## ATTACHMENT 3

PROPOSED CHANGES TO TECHNICAL SPECIFICATIONS  
3.8.1.2, 3.8.1.3, 3.8.2.2, 3.8.3.2 , 3.9.12 AND BASES

ST-HL-AE-4977  
Attachment 3  
Page 1 of 7

ENGINEERED SAFETY FEATURES BUS CROSS-CONNECT DESCRIPTION

# ESF TRAIN CROSS-CONNECT FROM BUS E1C TO EITHER BUS E1A OR E1B

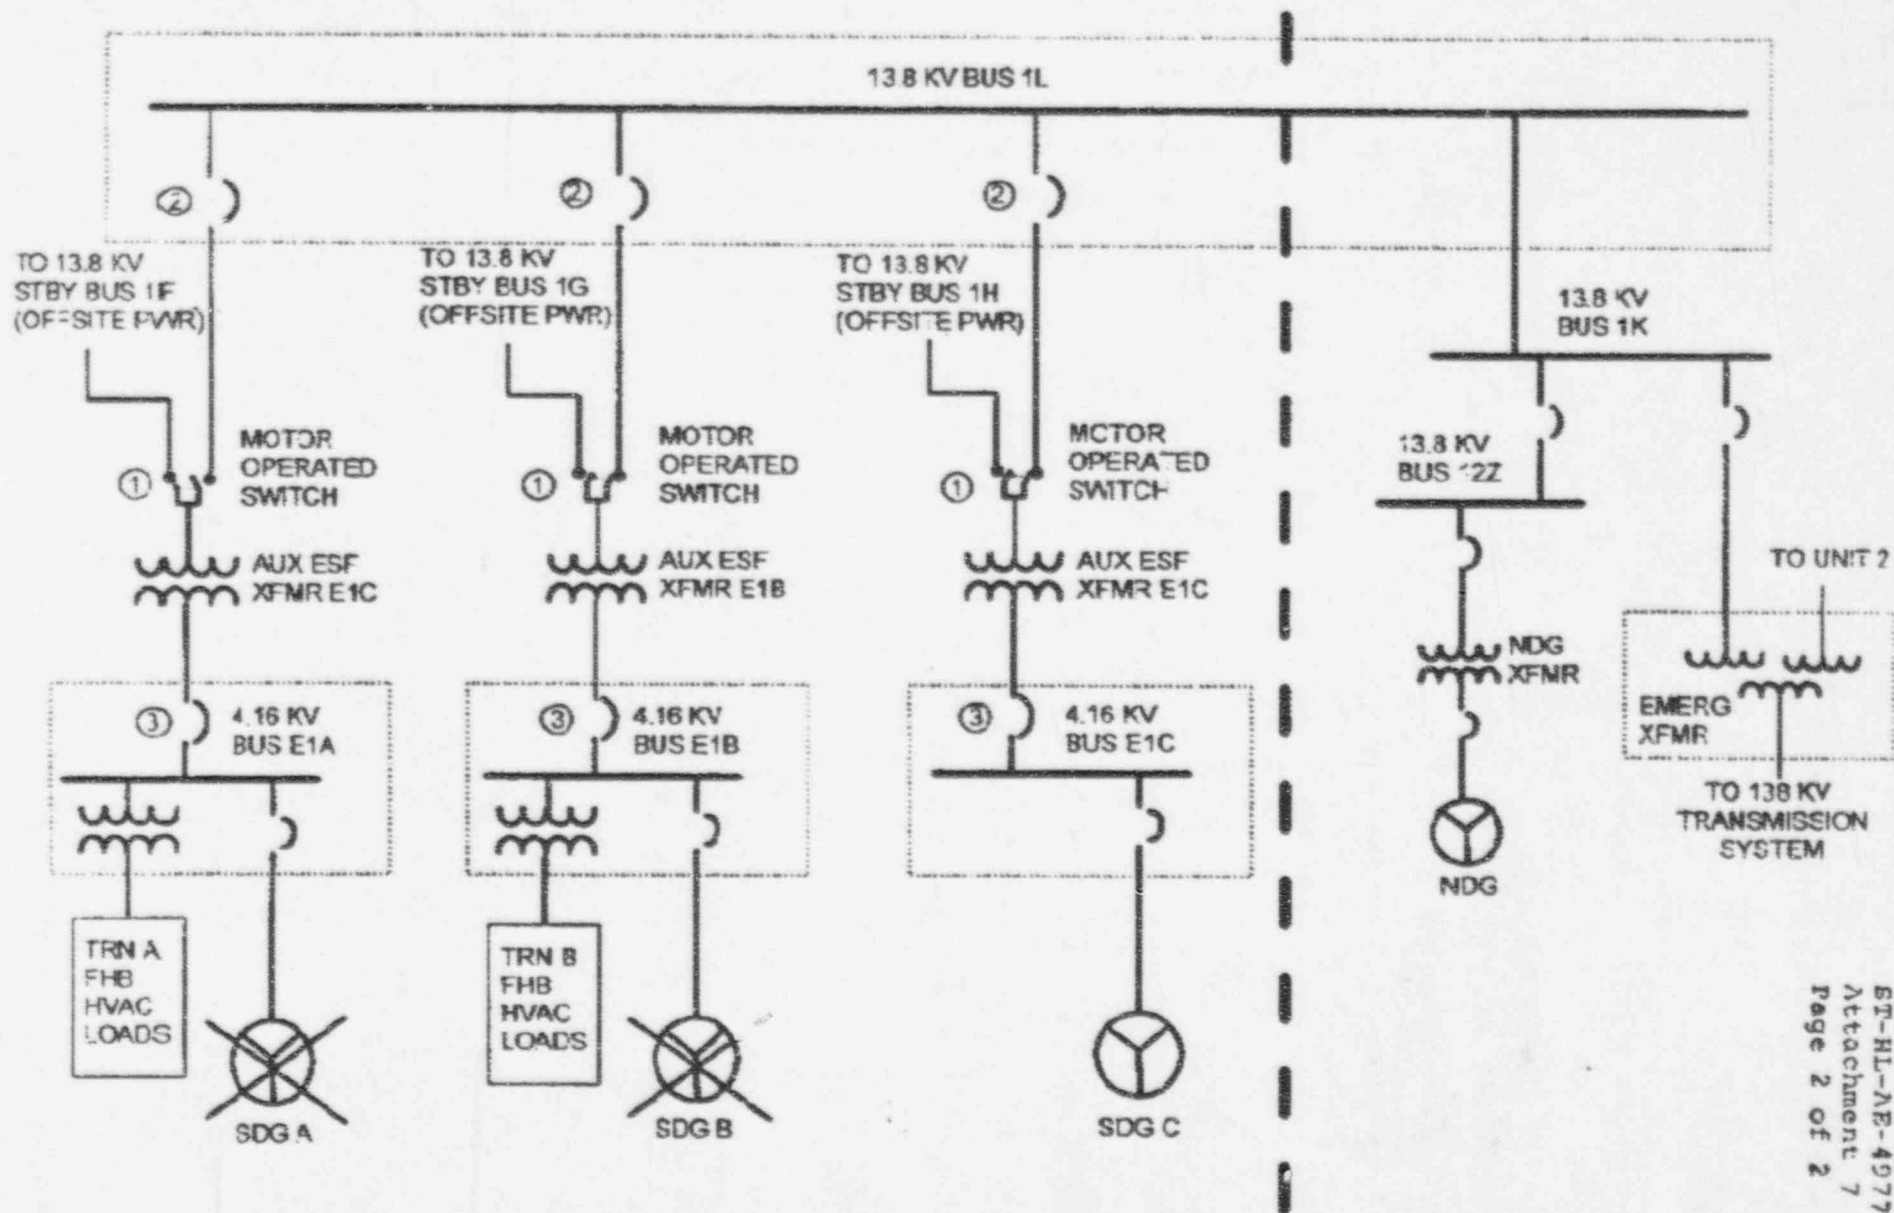
The following describes the steps required to connect one South Texas Project Engineered Safety Features train to another Engineered Safety Features train, via Emergency Bus 1L, any two Auxiliary Engineered Safety Features transformers, and the associated motor operated switches. This cross-connect scheme would be utilized to provide Standby Diesel Generator-backed power to the Fuel Handling Building HVAC heaters (114 kW per train) should no other preferred offsite power source or SDG-backed source be available. This description summarizes required actions following the postulated loss of AC power to Engineered Safety Features Buses A and B. The initial conditions for this scenario include: (1) SDG A and B are out of service; (2) SDG C is in the standby mode; (3) the NDG is available for service; and (4) Class 1E buses are supplied from offsite power. A loss of offsite power then occurs, followed by a fuel handling accident, the successful start of SDG C, and the successful loading of SDG C.

The specific steps required to cross-connect two Engineered Safety Features buses are detailed in Addendum 12 of STP procedure OPOP04-AE-0001, "Loss of Any 13.8 kV or 4.16 kV Bus". This description, augmented by the attached single line diagram, summarizes the steps for cross-connecting Engineered Safety Features Bus C to Engineered Safety Features Bus B. The cross-connect sequence includes opening the Engineered Safety Features Transformer E1B and E1C Motor Operated Switches (MOS) [#1] from the preferred offsite power source; closing the E1B and E1C MOS units [#1] to the Emergency Bus 1L source; closing the Emergency Bus 1L feeder breakers [#2] to Engineered Safety Features Buses B and C; and closing the Engineered Safety Features Bus B and C normal supply breaker [#3] to each 4.16 kV Engineered Safety Features Bus. Engineered Safety Features Bus B is then energized from the output of SDG C. The FHB HVAC loads may then be manually actuated and energized by SDG C. The NDG may be used to energize either the required safety-related loads (e.g., ECW, CCW, RHR), or the FHB HVAC heaters, in the unlikely event that all three SDGs and/or the Engineered Safety Features Bus cross-connect are unavailable.
